ZONING ORDINANCE

ORDINANCE NUMBER 2016-09

AN ORDINANCE OF THE TOWN OF PARADISE VALLEY,  
ARIZONA AMENDING THE PARADISE VALLEY ZONING  
ORDINANCE, Article XXII, HILLSIDE DEVELOPMENT  
REGULATIONS

RED TEXT IS DRAFT LANGUAGE  
PRESENTED TO PC AT 12/20/16 MEETING.

**FIGURE 2 – HILLSIDE DEVELOPMENT AREA**

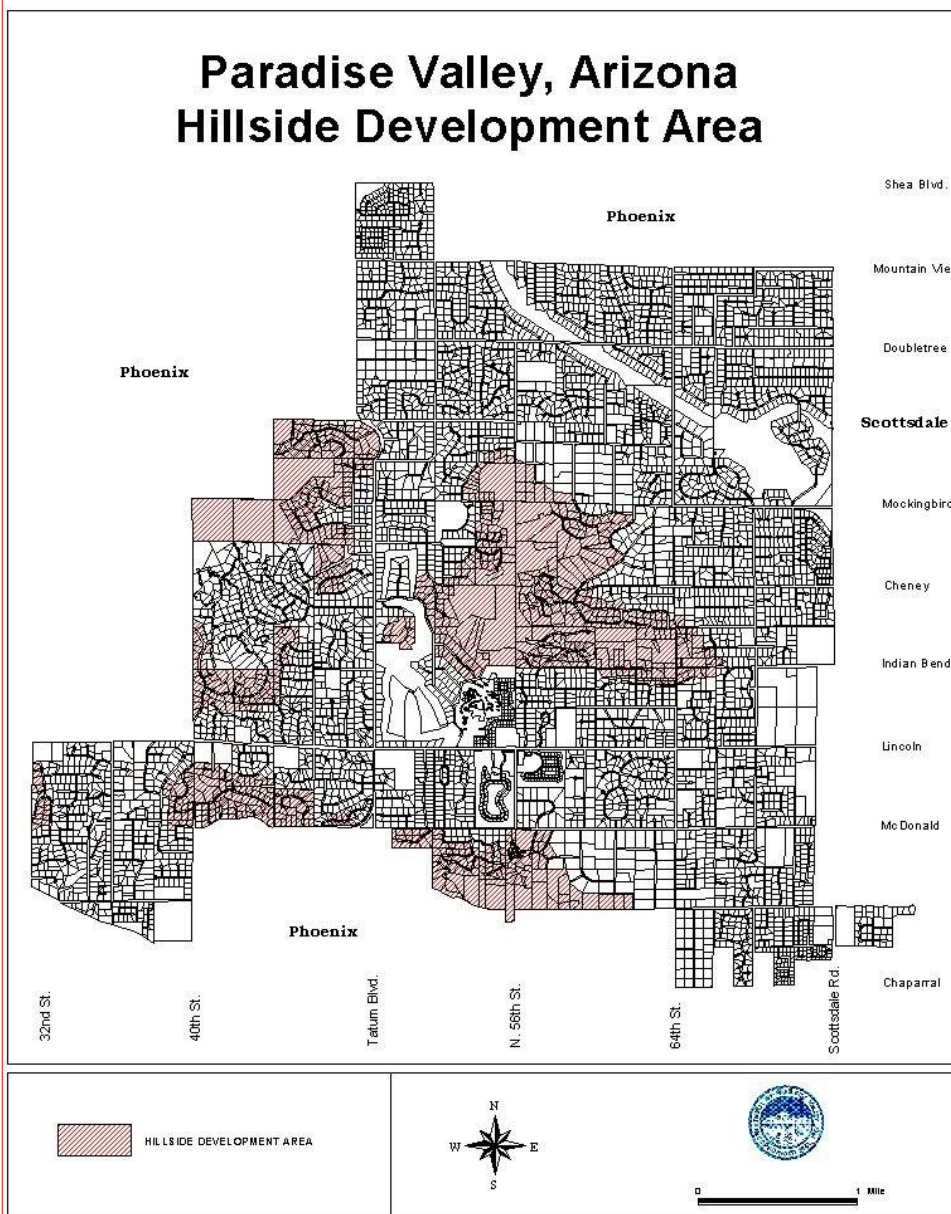
**Comment [GB2]:** Identify Process to Update Map with any properties removed from Hillside or added to Hillside

FIGURE 5 – BUILDING HEIGHT IN HILLSIDE

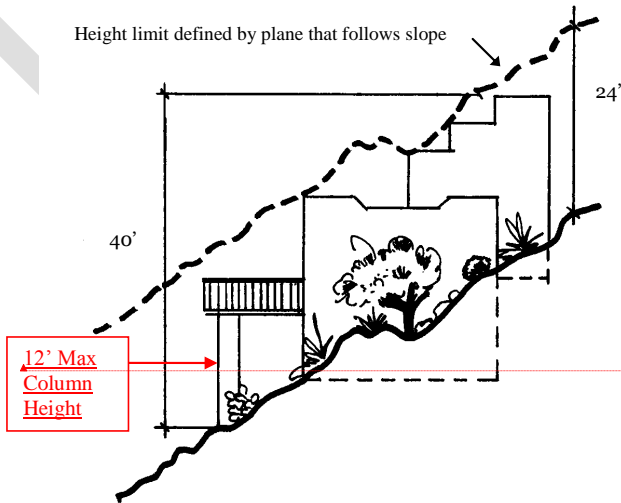
Comment [GB8]: Figure 5 to be updated to reflect these edits.

iii.3. The maximum overall height of the building or structure, including chimneys and accessory buildings, shall not exceed forty (40) feet from the highest point of the building to natural grade at the lowest point adjacent to the building structure or column of a building or structure to the lowest point of Natural Grade at the lowest building or structure (excluding driveway retaining walls) --(see FIGURE 5).

FIGURE 7 - HEIGHT FOR A CANTILEVERED ELEMENT

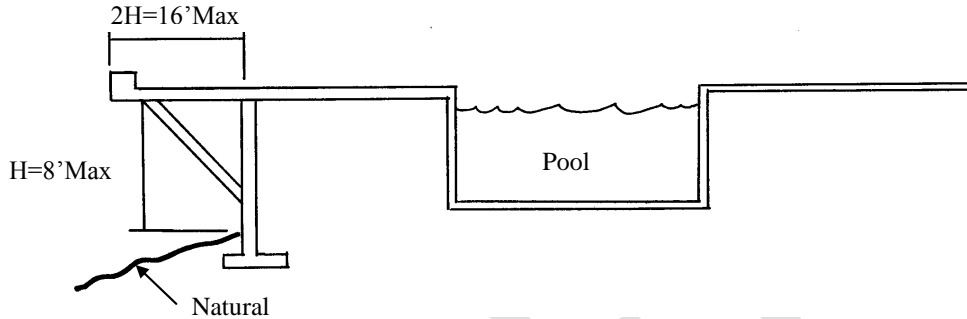
~~B. Structures employing the use of a cantilever may extend the cantilever a horizontal distance twice the height of the support. The maximum vertical height of the support shall be eight (8) feet. One half the area underneath the cantilevered element shall be calculated as disturbed area. (See FIGURE 7 below).~~

**Comment [GB10]:** New figures to be added to the code to illustrate these scenarios.

**Comment [GB11]:** There was no consensus regarding the proposed changes to the limitations on cantilevers at the 1/3/17 PC Meeting. It was recommended that staff research other city codes to see how different communities address cantilevers, provide several pictures of cantilevers for reference, and to include the entire area underneath a cantilever as disturbance.

FIGURE 8 – TERRACED VERTICAL RETAINING WALLS

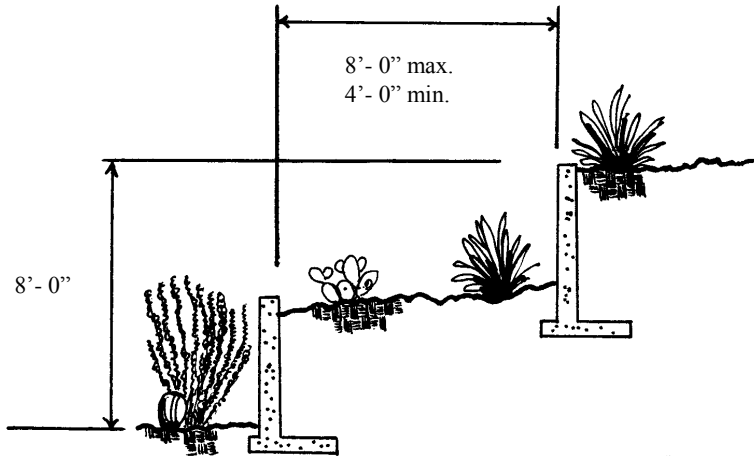
Comment [GB15]: Relocate Figure 8 below the text of 2207.VI.1.e.

e.c. A terraced combination of retaining walls shall be measured as a single retaining wall provided the combined walls are: 1) no more than eight (8) feet total vertical height; 2) terraced with a minimum distance between of four (4) feet and a maximum separation of eight (8) feet; and 3) contain appropriate vegetation between the walls so as to soften the visual impact of the combined walls (see **FIGURE 8**). These separation requirements apply to any single lot and do not apply to adjoining walls on neighboring properties.
